**LAKE PONTCHARTRAIN, LA.
AND VICINITY
LAKE PONTCHARTRAIN
HIGH LEVEL PLAN**

**DESIGN MEMORANDUM NO. 19
GENERAL DESIGN**

**ORLEANS AVENUE
OUTFALL CANAL**

ENGINEERING CORRESPONDENCE LOG

FIGURE 2

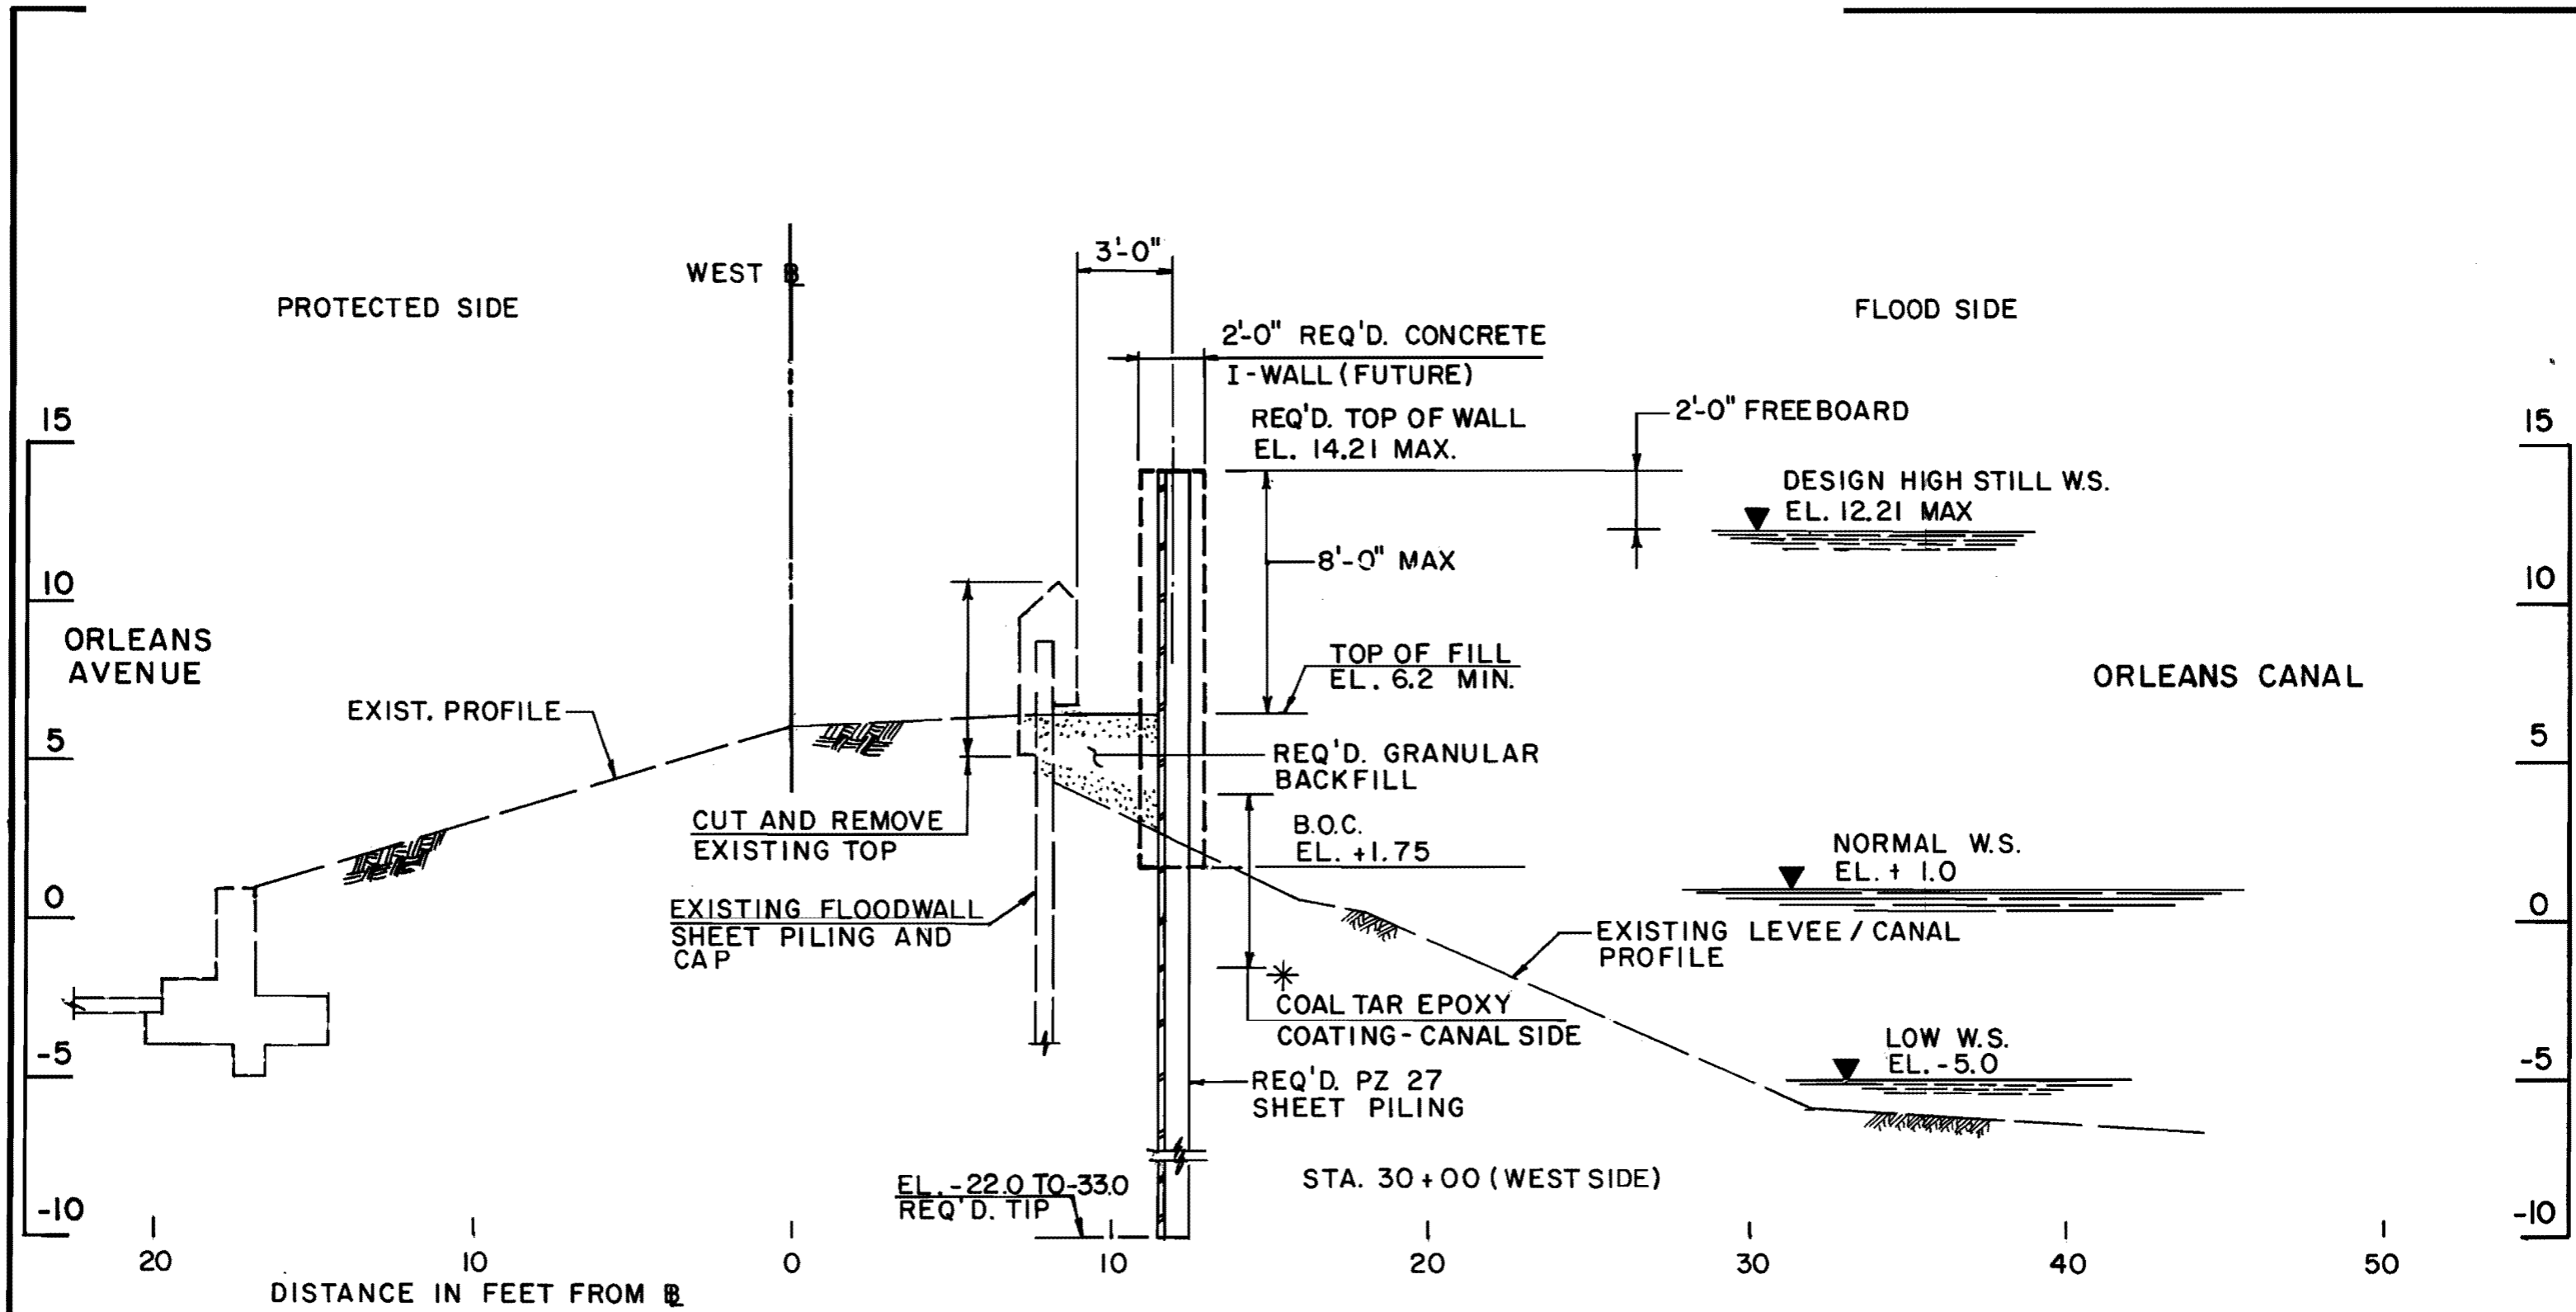
16. Page V-4, paragraph 4, figure 2, and figure 7 - The draft geotechnical report has a tip elevation of -37.5 NGVD for the I-wall between sta. 50+00 and sta. 90+00, whereas figures 2 and 7 show a tip elevation of -33 NGVD. Reference comment 15 in our February 10, 1986 letter.

19. Figure 2 - The proposed elevation limits for coating the steel sheet piling with coal tar epoxy should be provided. It should be noted that the use of the coal tar epoxy, in lieu of the requirements of para. IV.D.1, is only permitted in this reach.

Comment 19. The elevation limits for coating the steel sheet piling will be shown in Figure 2.

FIGURE 4

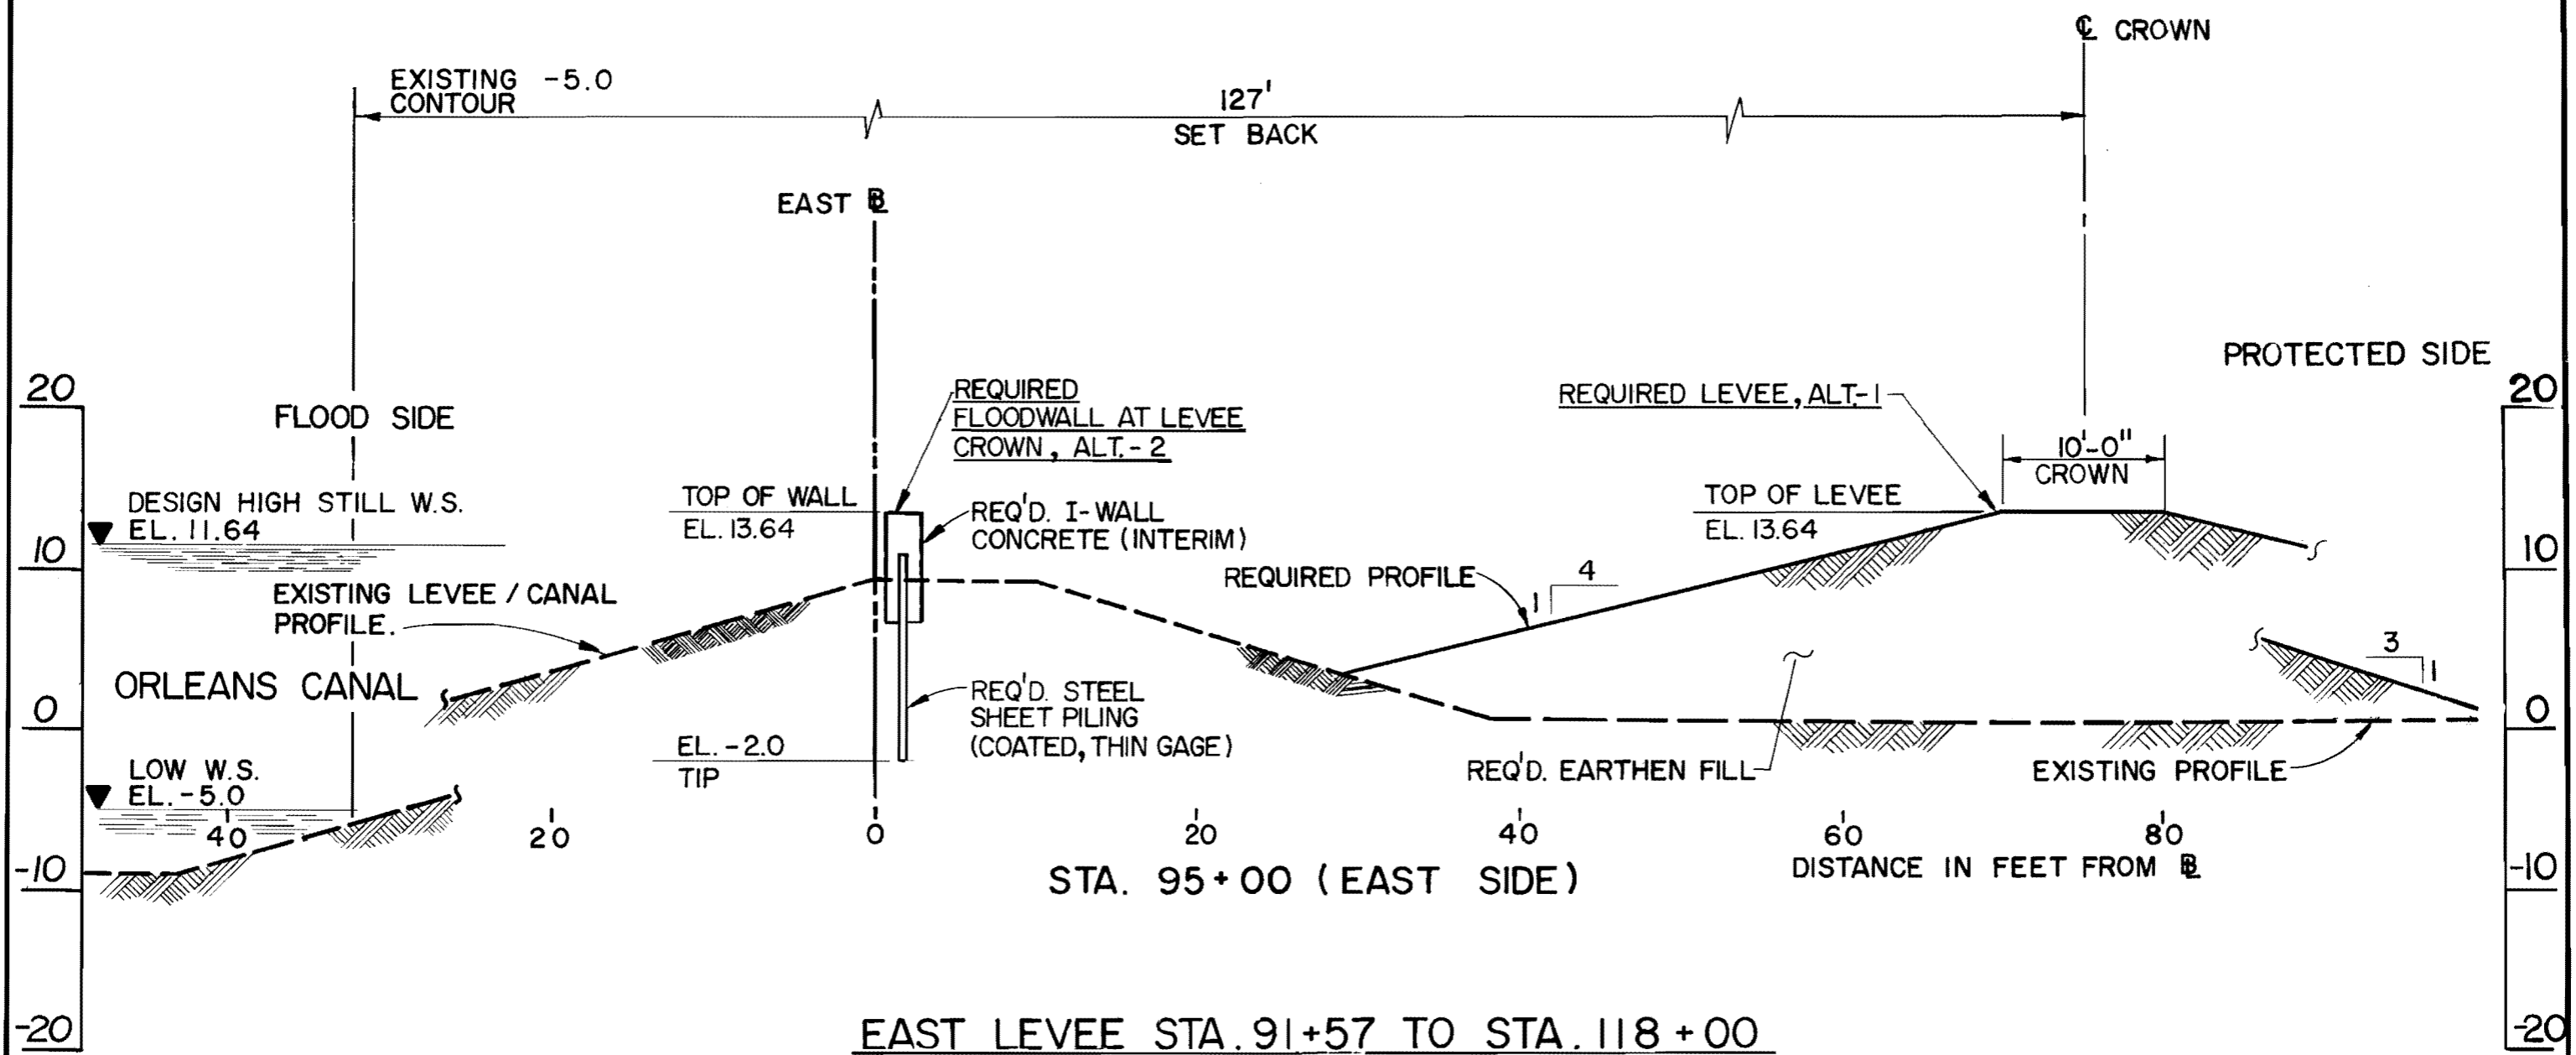
17. Figure 3, Typical East Levee Modification, Sta. 3+54 to Sta. 89+75 - The natural ground surface of approximately El 0.0 NGVD shown on the landside is not indicative of the natural ground surface between Sta. 3+54

FIGURE 5

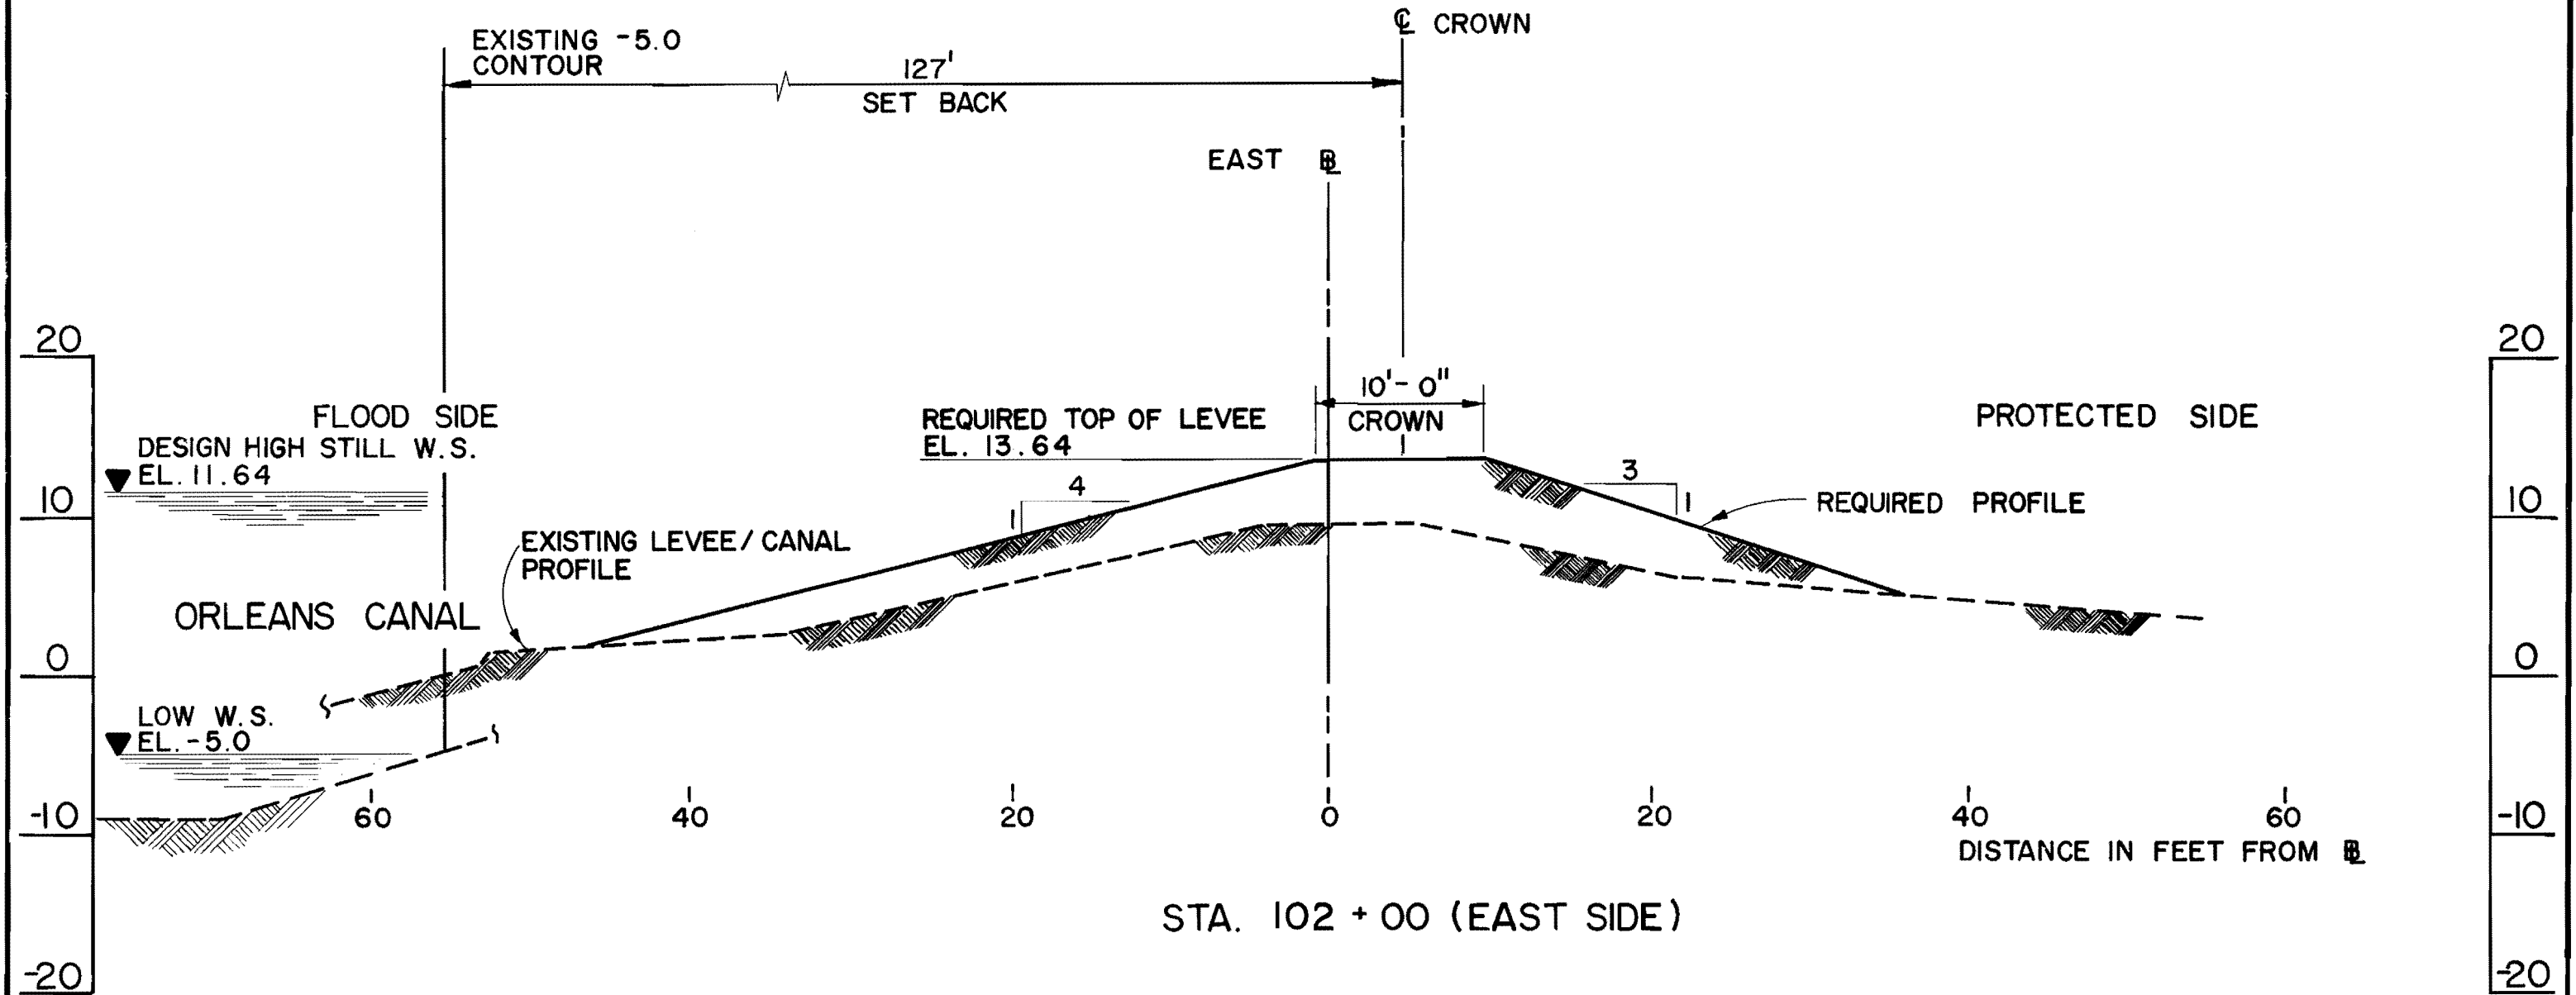
20. Figure 5 - It appears that this proposed section is for the west side, and not the east side as shown. This should be resolved.
